Taylorcraft

Taylorcraft Aviation Corporation

SERVICE BULLETINS

Service Bulletin Index

SERVICE BULLETIN # 32

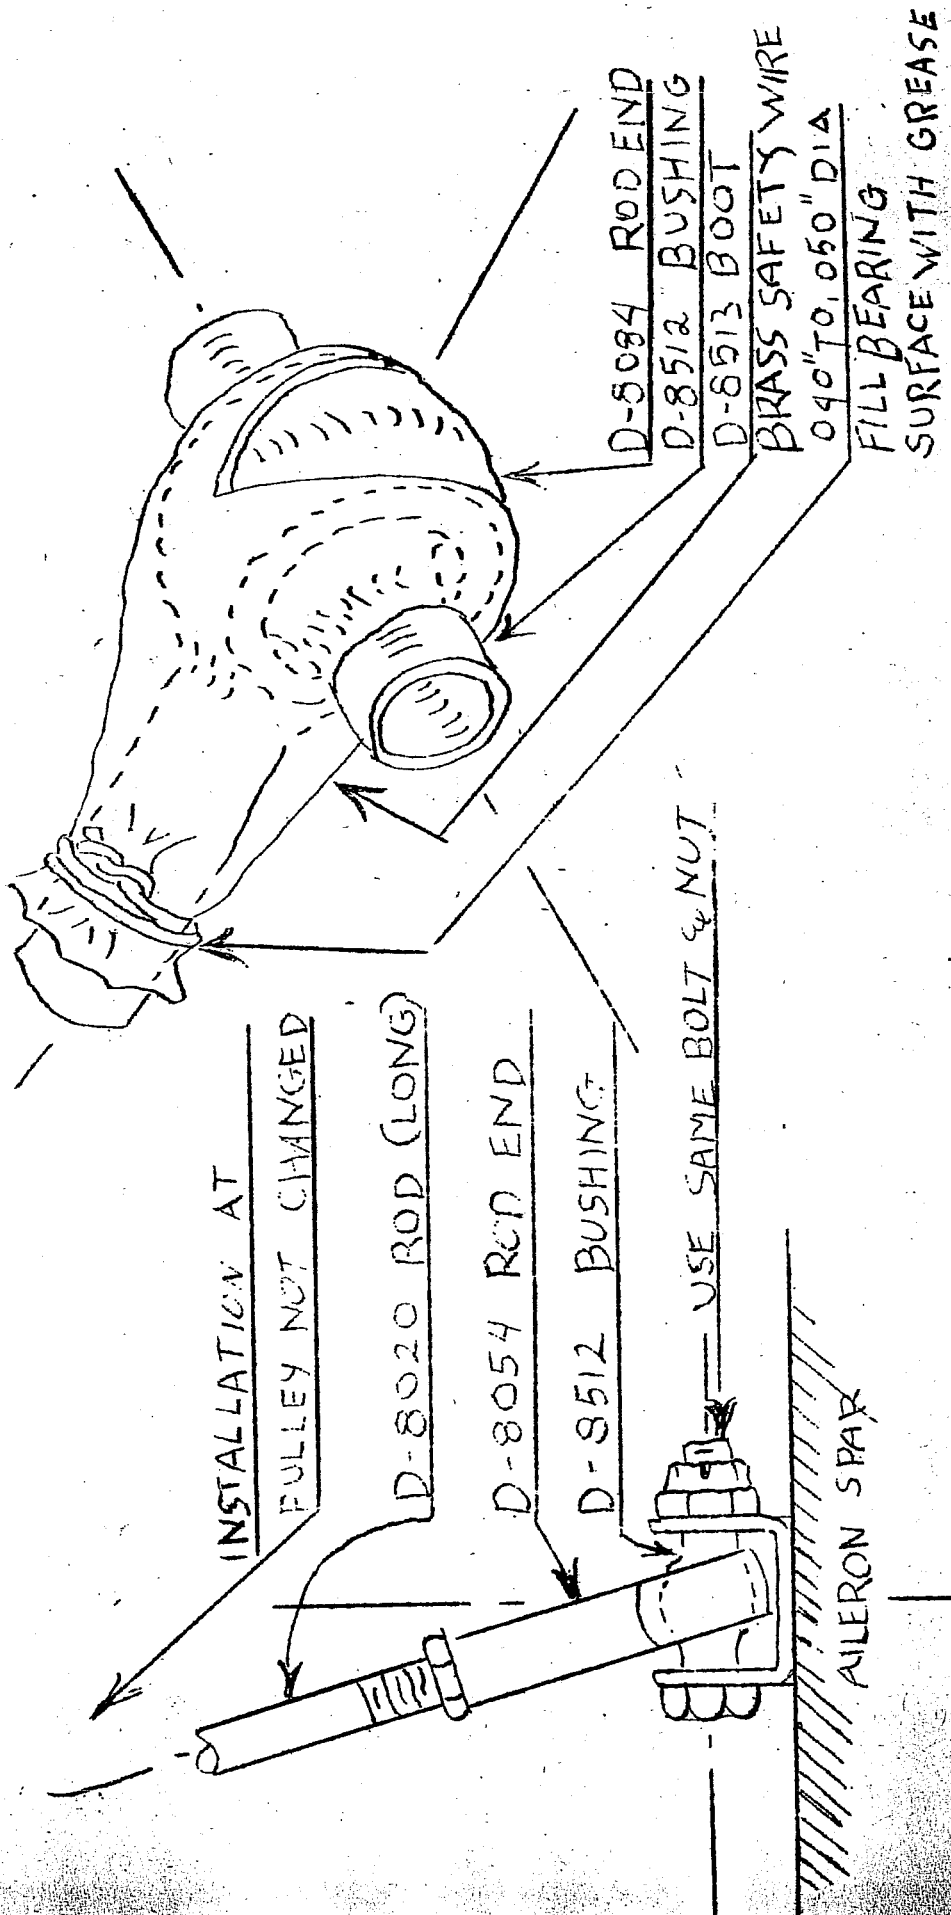
LOCATION AFFECTED: Wing & Aileron, aileron activating link.

PART AFFECTED: Aileron drag link installation.

CHANGE NECESSARY: Remove link from pulley in wing & fitting on aileron control point. Reinstall according to attached diagram using new parts enclosed.

PARTS NECESSARY: Additional parts enclosed D-8020, D-8054, D-8512, and D-8513.

BOOT SHOULD BE INSTALLED OVER ROD END & BUSHING AS SHOWN TO THE RIGHT BEFORE LINK IS INSTALLED AT AILERON

— FIG. 1 —

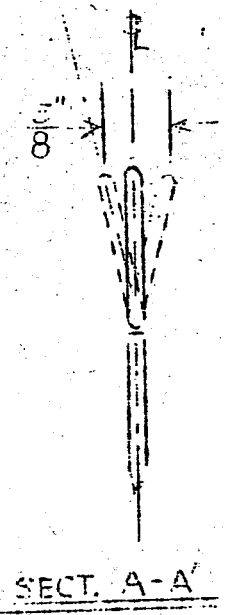
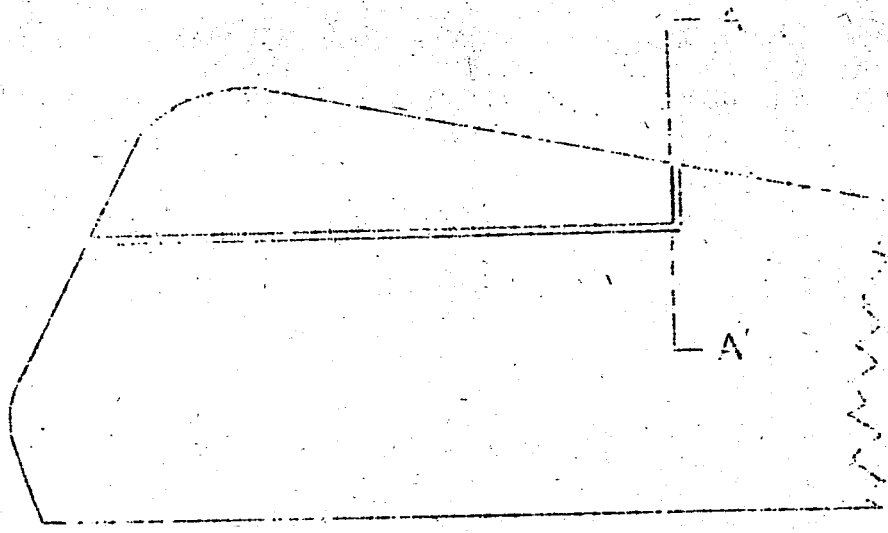
Reason for Change: Eliminate possibility of flutter in trim tab surface

1. Run tab from extreme "nose down" position to neutral.
2. Grasping the trailing edge of the surface, determine the amount of travel in the tab surface at the trailing edge. (Fig. 1)
3. If this travel is $3/8$ " or less this bulletin has been accomplished, the mechanism is considered satisfactory and the remainder of the bulletin is void.
4. If this travel is in excess of $3/8$ ", remove the inspection plate in the lower surface of the elevator giving access to the trim tab activating mechanism.
5. By moving the tab surface through its angle of play several times, the joints in the system showing a large amount of play can be determined.

6. If selecting and installing new bolts manufactured to the high side of their tolerance does not result in bringing the play of the surface within $3/8$ " as described in sections 1, 2, and 3 above, the parts indicating excessive wear by the play in the joints should be replaced in order to accomplish this.

— FIG. 2 —

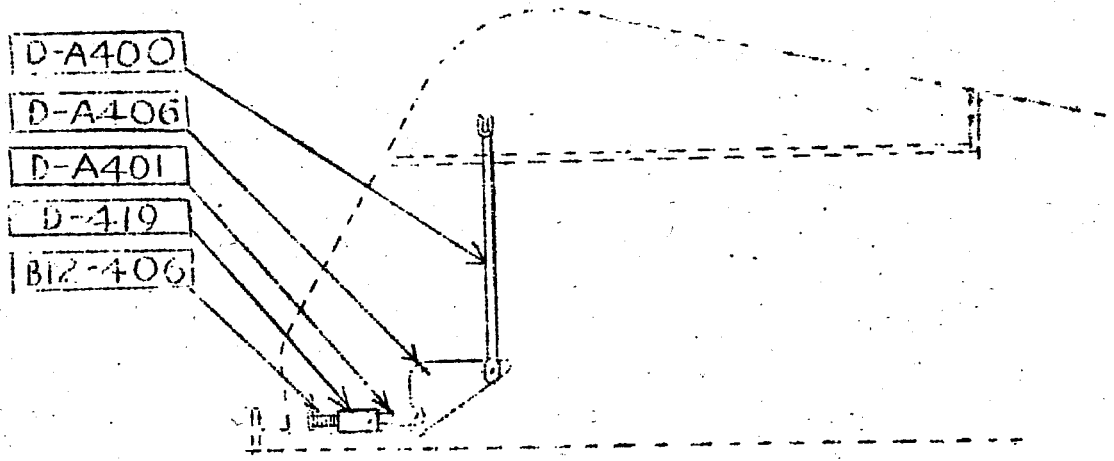
Parts Required per Airplane: Parts required (See Fig. 2) and their number are indeterminate. They can be secured from the factory by writing and indicating the parts needed, the model and serial number of the ship for which they are being purchased.
